STAFF RECOMMENDATION

1702 Sweetbriar Avenue
September 21, 2016

Application: New construction - infill

District: Belmont-Hillsboro Neighborhood Conservation Zoning Overlay

Drawings:
Site Layout Plan
Date:
09.01.16

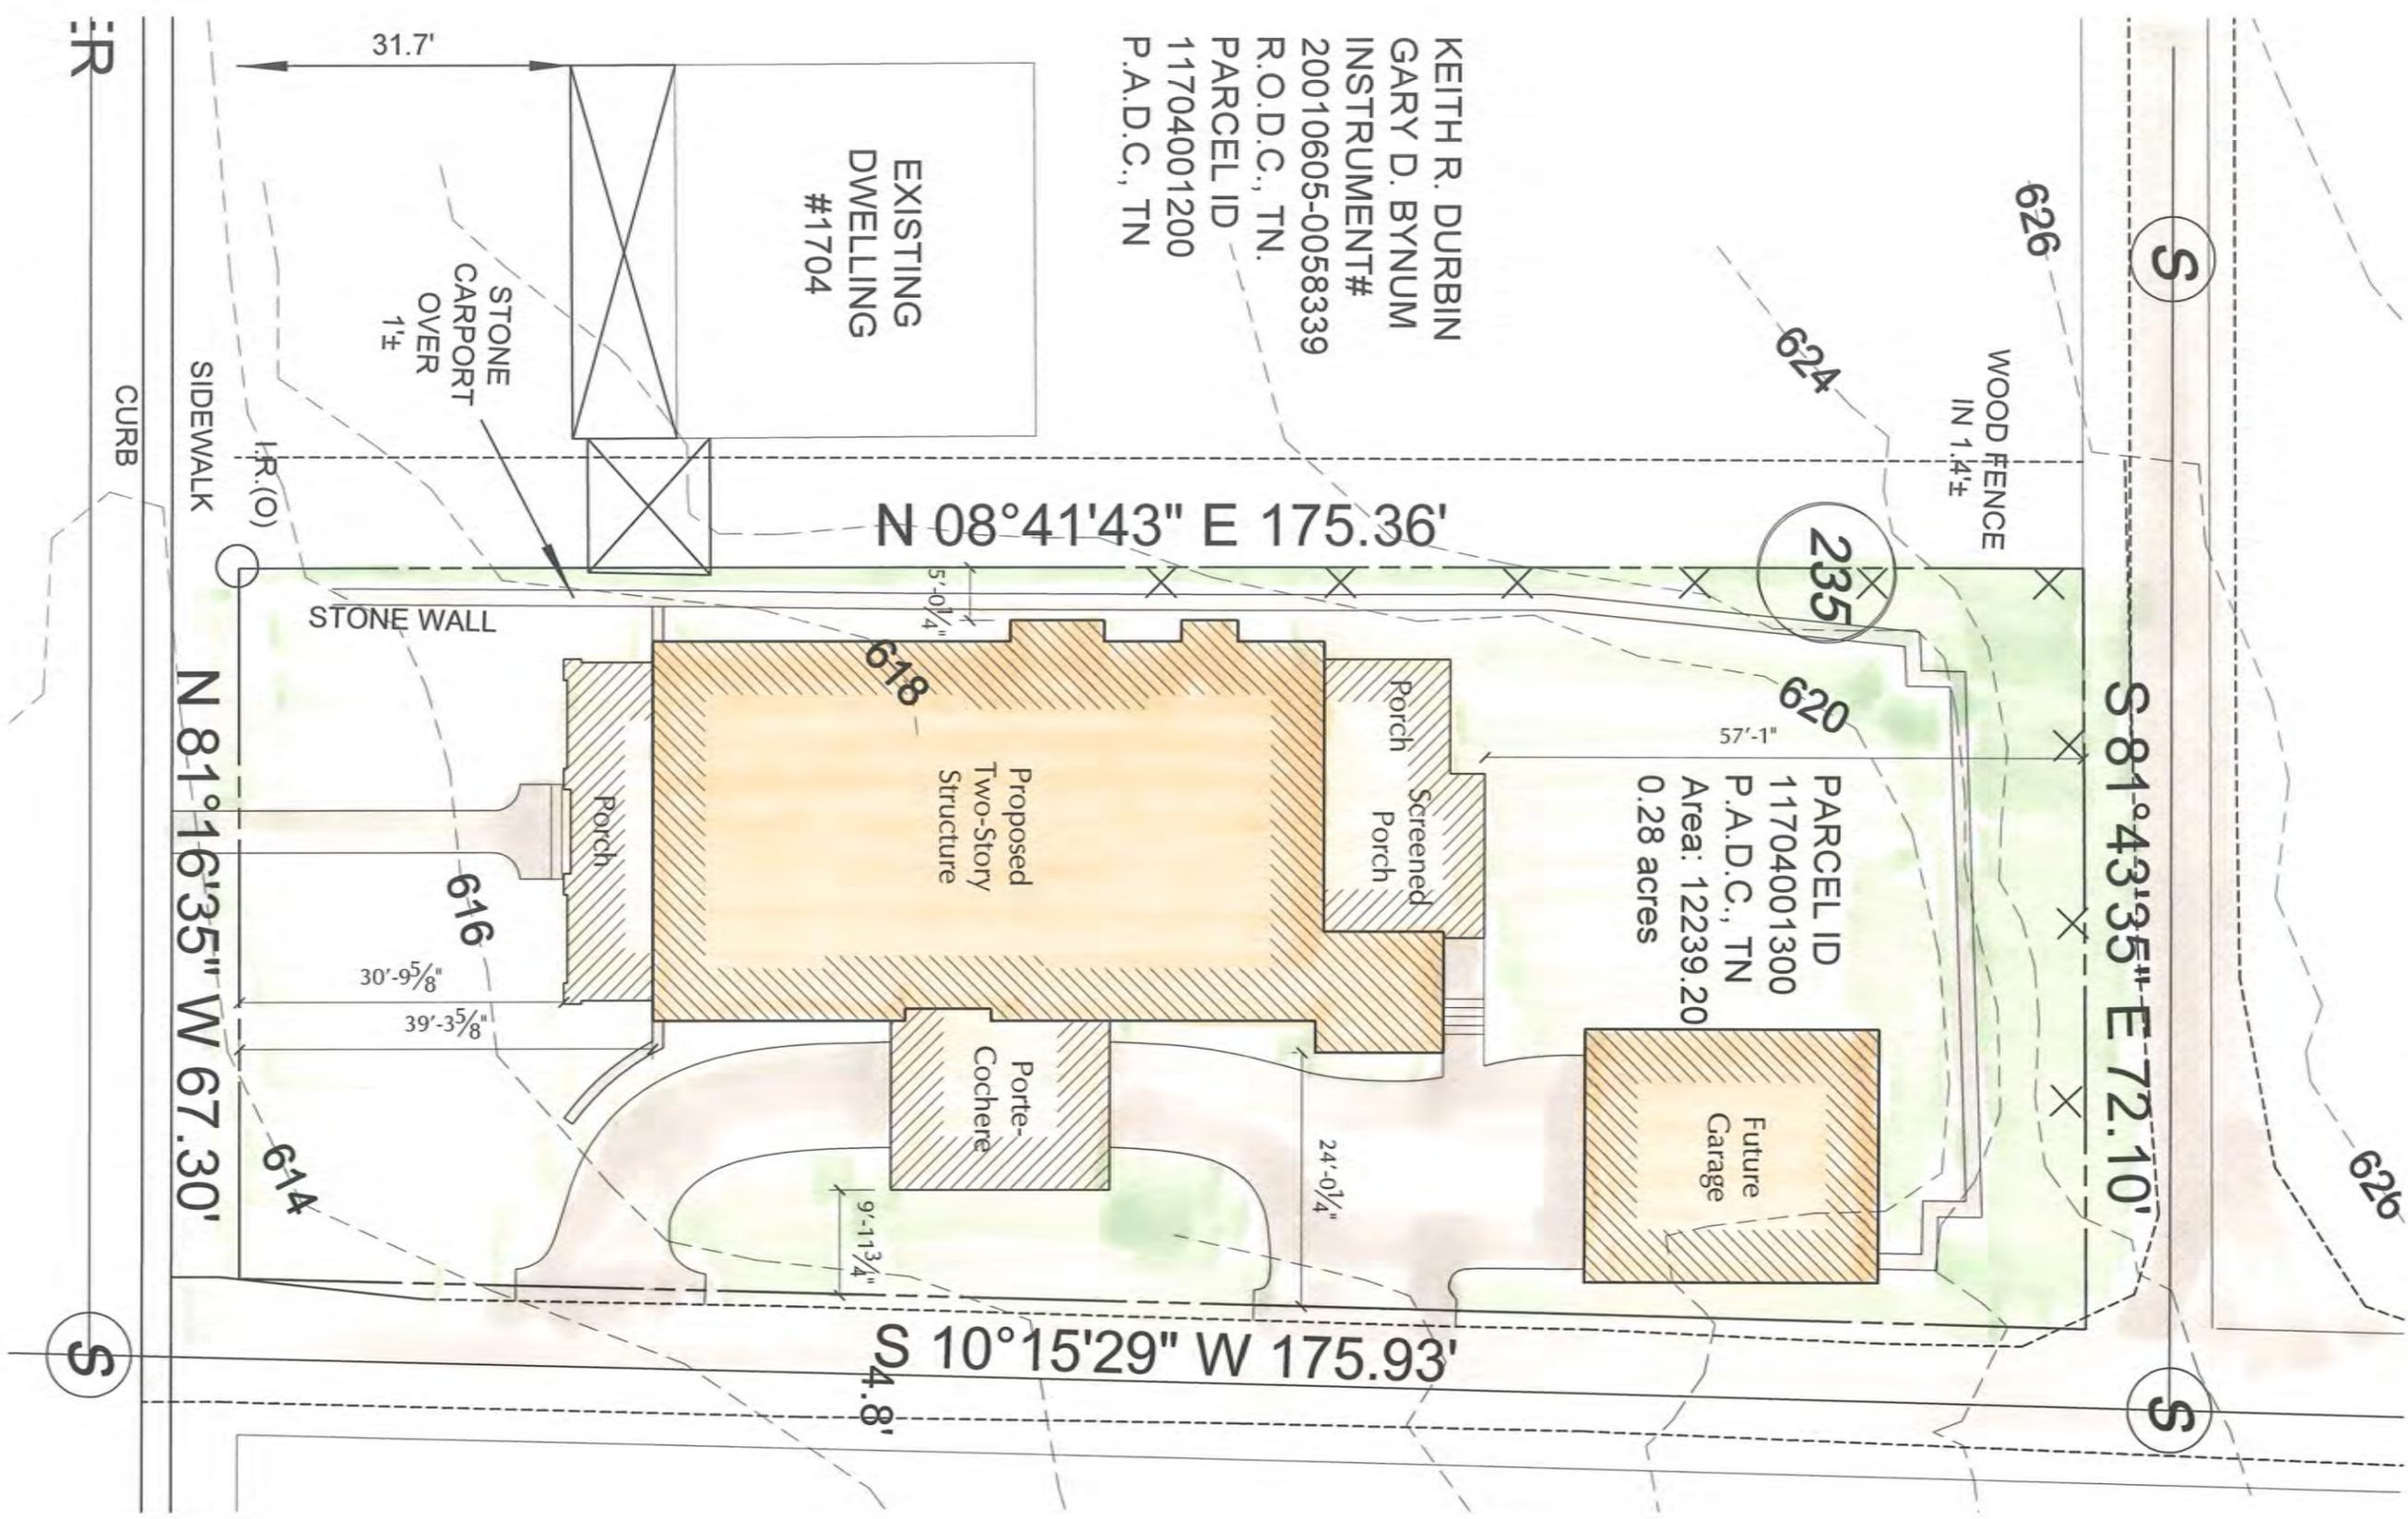
Outbuildings: The site plan shows a “future outbuilding” for which no other information has been submitted. An outbuilding may be reviewed later upon submittal of a complete application.
